MEMORANDUM

DATE: April 26, 2024

RE: Greenburgh Hebrew Center

Greenburgh Hebrew Center (the “Applicant” and “Owner”) is seeking Site Plan approval construct a new playground and complete various improvements to the existing parking lot and associated driveways and sidewalks on the lot. The property is located at 515 Broadway, Section Block and Lot 3.40-4-11 (“Project Site”) and is located in the OF-1, One Family Residential 1, zoning district.

5. **Zoning.** The Applicant provided a zoning table for the OF-1 district. We note the following:

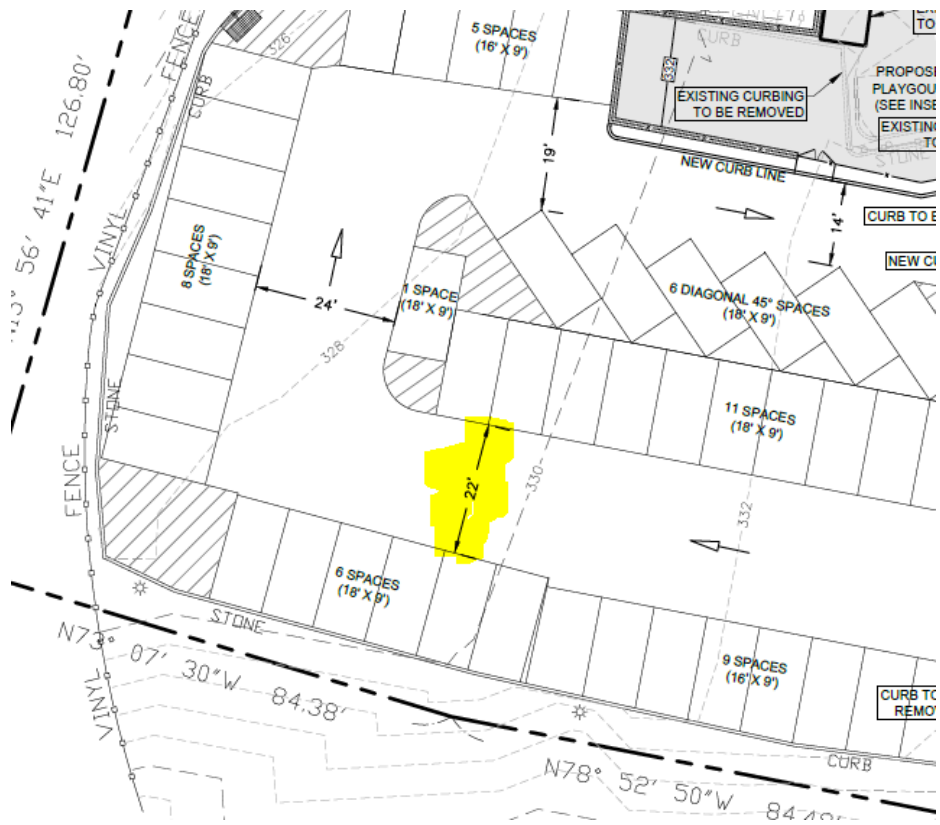
- a. Building coverage. The permitted amount of building coverage is 15%, however the existing building presents 27% coverage. We note the Applicant is proposing the removal of an existing shed, which decreases the overall non-conformity.

- b. Impervious coverage. The OF-1 zoning district permits a maximum of 30% impervious coverage, however the lot presents 74% coverage. The Applicant has indicated a slight decrease in the impervious coverage resulting in a decrease in the non-conformity.

- c. Parking Design. Please see the Site Plan comments on the parking lot design regarding waivers that will need to be granted by the Planning Board in accordance with § 300-52E. If the Planning Board decides not to approve the waivers, the Planning Board will need to refer this application to the Zoning Board of Appeals to obtain variances from §300-48D.
